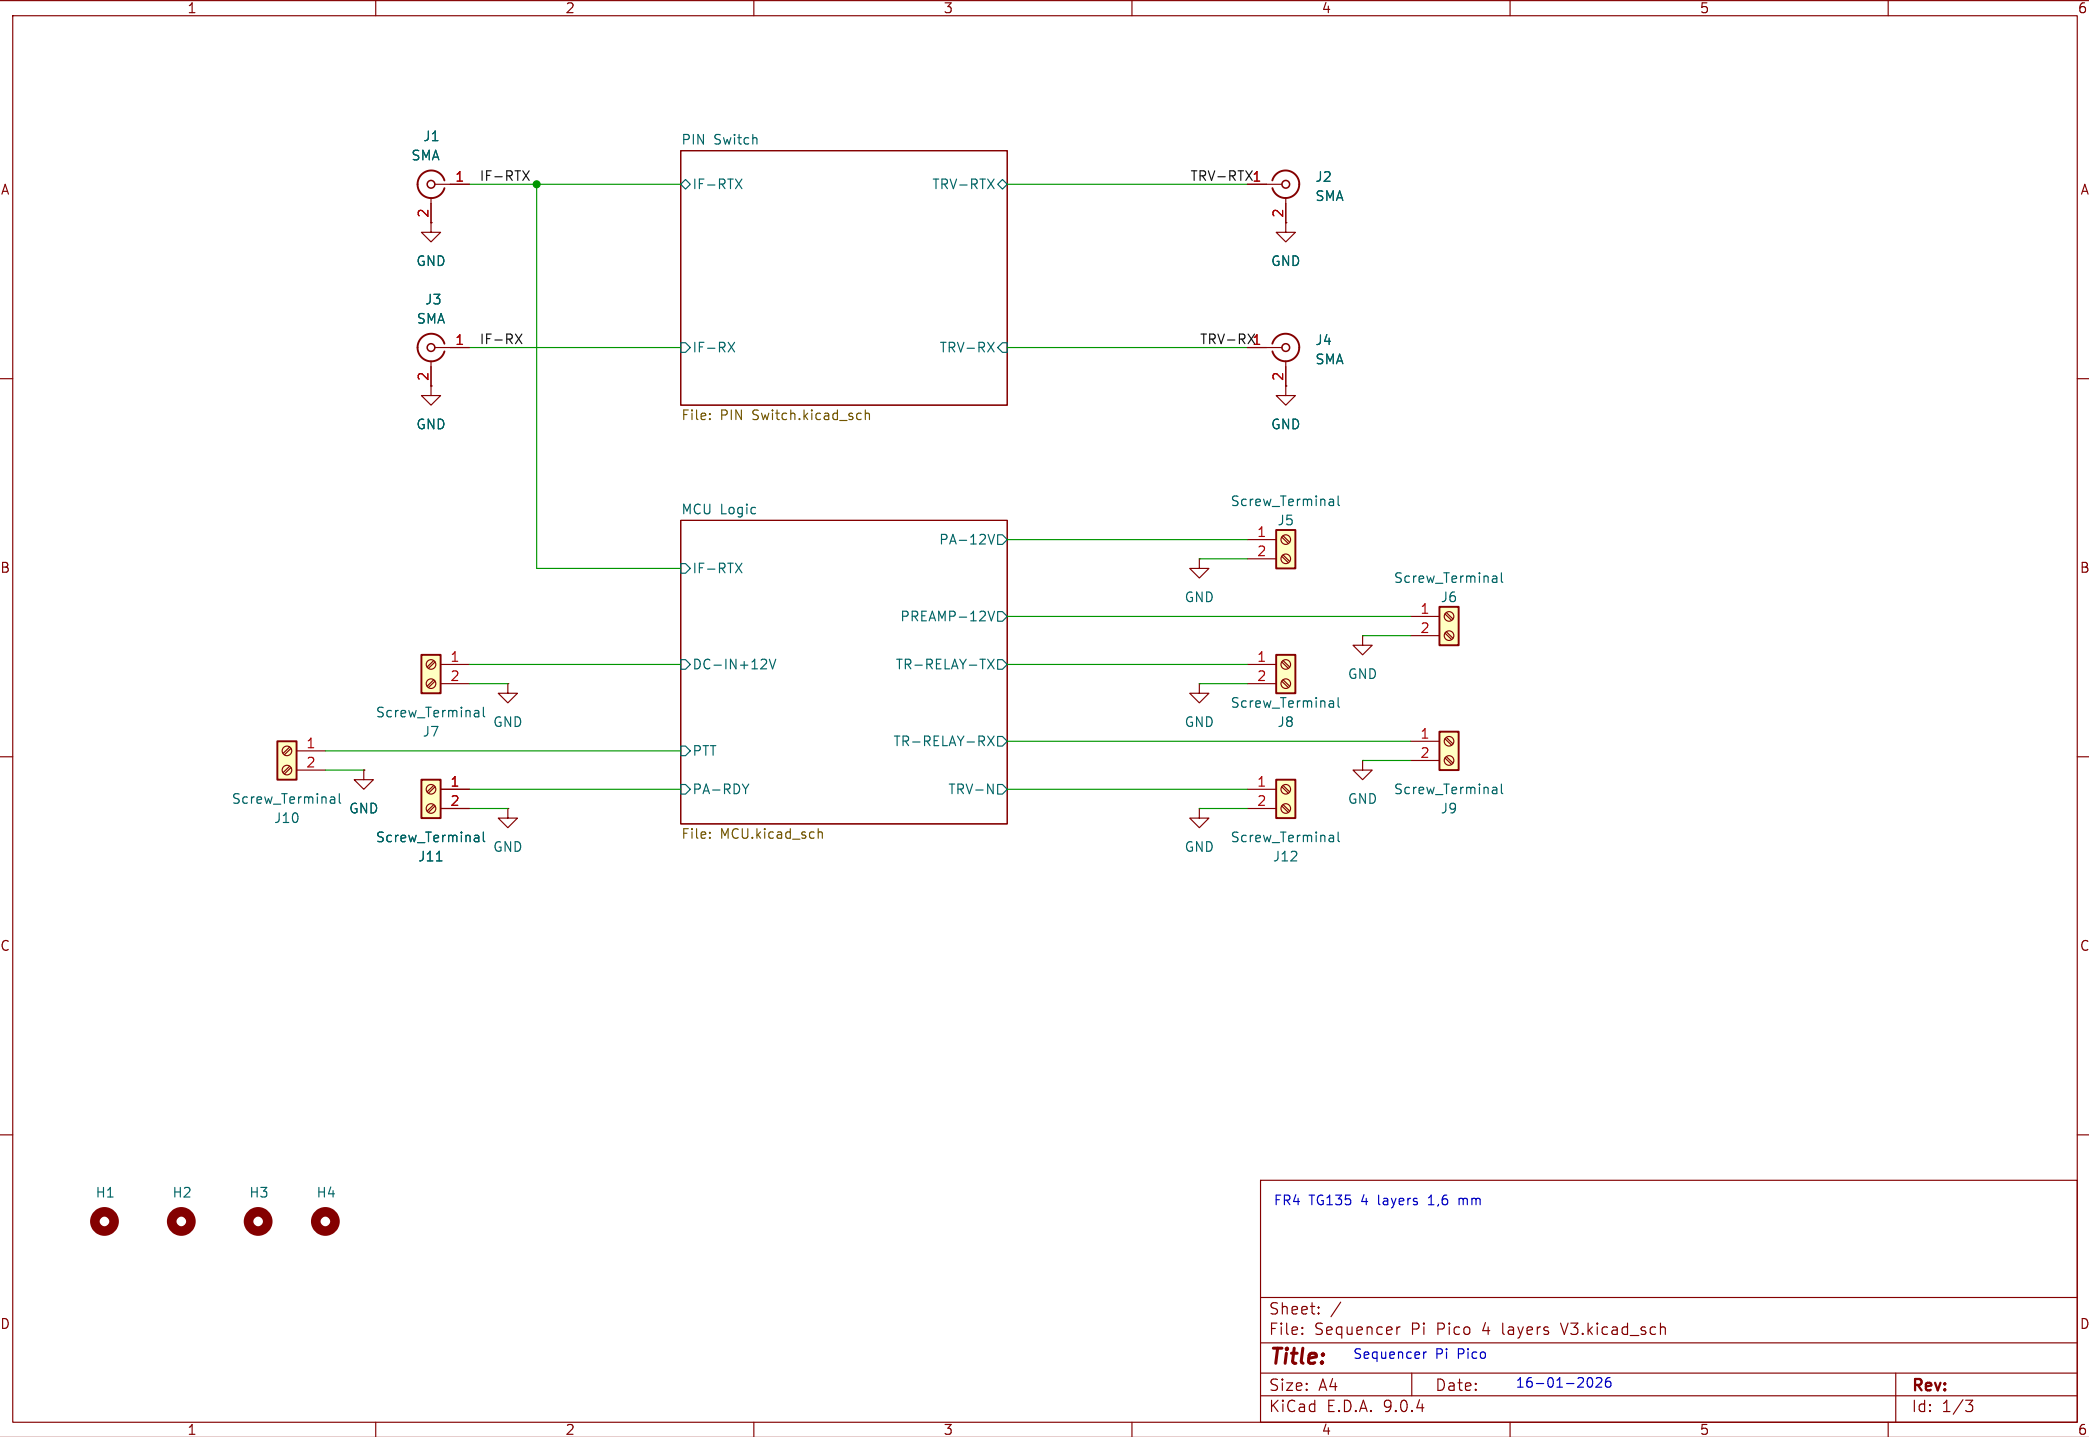
For seperate IF RX:
D4 – removed
R11– removed
C8 – installed

For separate Trv RX:
D5 – removed
R14– removed
C11– installed
